EMF-2103(NP)(A)  
Revision 0

# Realistic Large Break LOCA Methodology for Pressurized Water Reactors

April 2003

Framatome ANP Richland, Inc.

# FLECHT-SEASET Test 31302

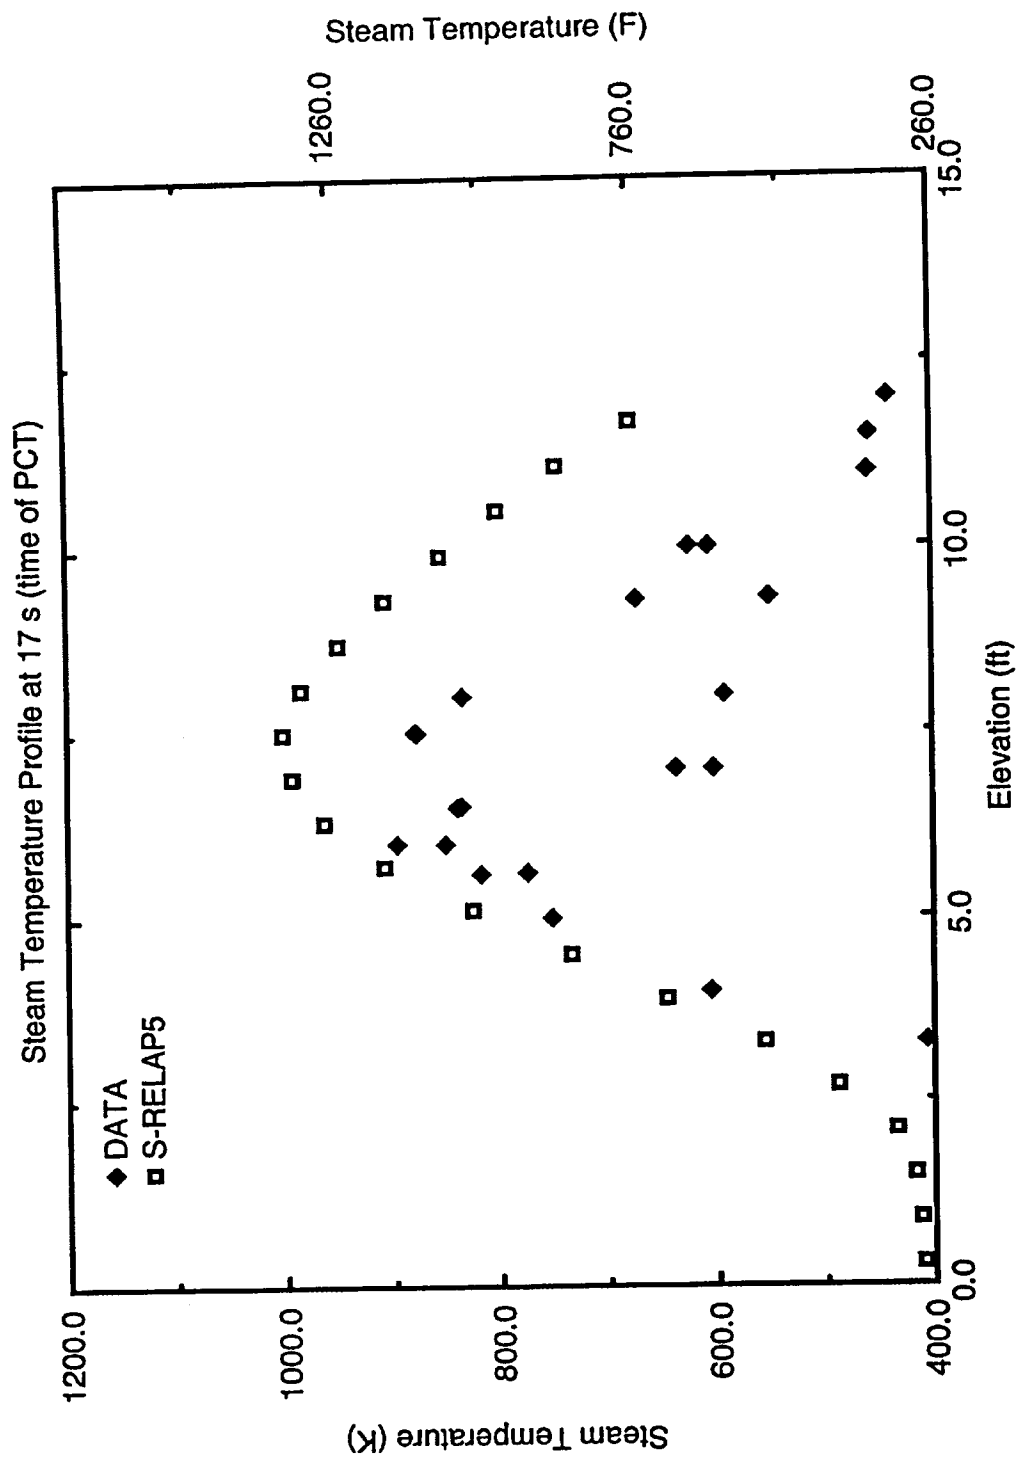
An overall comparison of the performance of the steam cooling model can be seen in Figure 1 (attached to this SE); the steam temperature at the time of PCT for FLECHT-SEASET Test 31302. The steam temperature predicted by S-RELAP5 is conservative relative to the measured steam temperature. The higher predicted steam temperature results in lower, conservative, heat transfer from the fuel rod simulators.

**Figure 4.35 Maximum Clad Temperature at All Measured Elevations,  
FLECHT SEASET Test 31504**

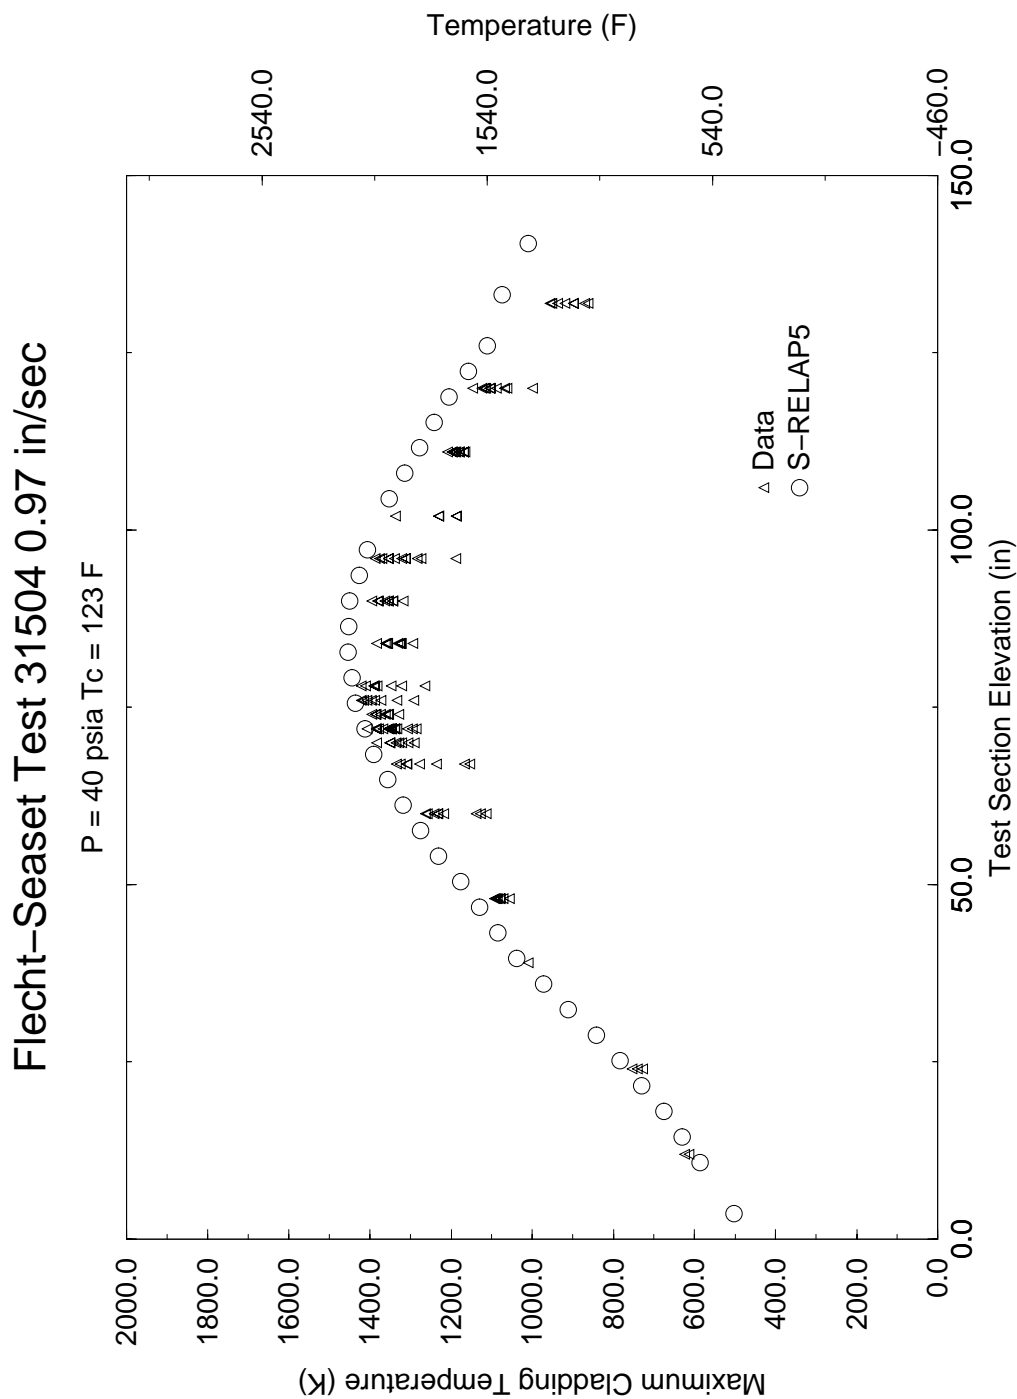
Before discussing the results of the review of the 2D/3D assessments, two examples are given of the assessments presented by Framatome ANP. Figure 2, Framatome ANP RLBLOCA Figure 4.35 taken from Reference 3, attached to this SE, shows the comparison of the S-RELAP5 maximum cladding temperature calculation versus the measured temperature for FLECHT-SEASET Test 31504. The figure shows that the code is conservative with respect to the measured cladding temperature throughout the length of the test assembly. Figure 3, Framatome ANP RLBLOCA Figure 4.194 taken from Reference 3, attached to this SE, shows the comparison between the S-RELAP5 predicted cladding temperature and the measured cladding temperature for LOFT test LP-LB-1. Two S-RELAP5 predictions are shown, one made without accounting for the code biases determined from the separate effects test assessments, and one made with the biases taken into account. Again, the code predicted cladding temperature is conservative relative to the measured temperature throughout the test assembly except at the very top of the fuel assembly. At that point, the temperature is significantly below the PCT. It is also noted in the LOFT assessment that the effect of considering the biases is to bring the code predicted temperature into close agreement with the measured temperature with the attendant data error bands.
